E-22051
March 7, 2005

Subject: RAI Response for the NUHOMS® HD Storage System Docket No. 72-01030.
(TAC No. L23738)

3-16 Provide a brittle fracture analysis to evaluate the fracture toughness of the transfer cask bolts,

Figure 3-40
Effect of Tempering Temperature on Notch Toughness

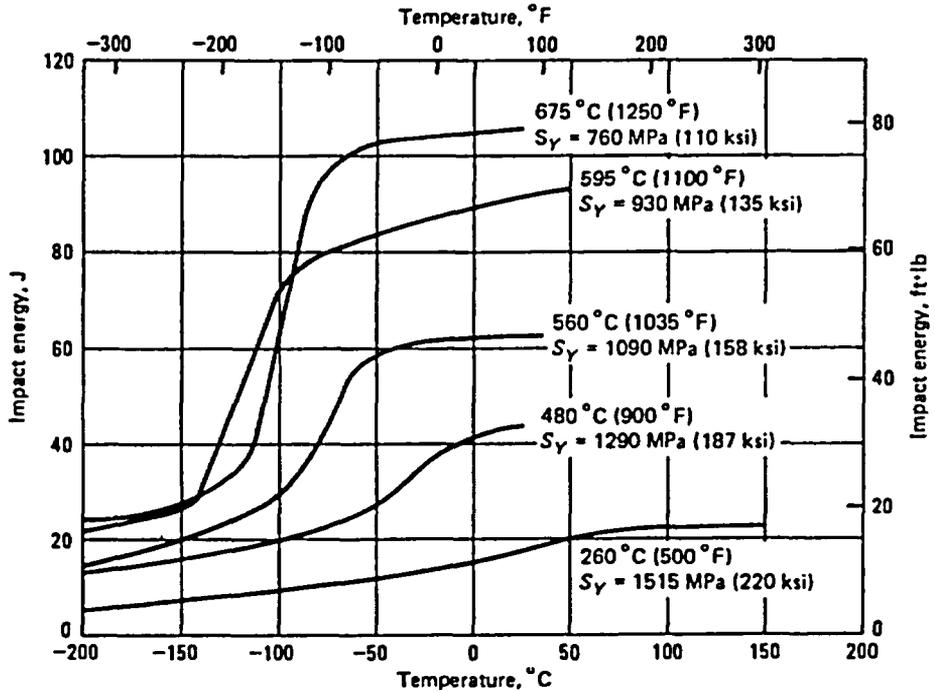
The statement concerning brittle fracture is not a concern because all the components comprising the transfer cask are all stainless steel, is not a true statement. As stated in 3.1.1.3 of the SAR, non-stainless steel members include the carbon steel closure bolts. The SAR does not have any supporting analysis or evaluation to demonstrate that these bolts will not fracture while in-service.

ASM Metal Handbook (Volume 1) [3-18], Figure 26 (reproduced here in Figure 3-40) shows that a 4340 steel tempered at 1035°F for 1 ½ hours to produce a yield strength of 158 ksi exhibits a very low Charpy impact transition temperature (< -20°F) and an upper shelf energy of about 45 ft-lbs at -20°F.

Material Grade	Yield Strength (ksi)	Charpy Value, -20°F (Ft-lbs)	Charpy Value Used for Brittle Fracture Evaluation (Ft-lbs)
4340 Steel Tempered at 1035°F for 1 ½ Hours (Fig. 3-40)	158	45	
Medium-Carbon Low Alloy (Fig. 3-41)	149	30	
SA-540 Gr. B24 Cl. 1	150		20**
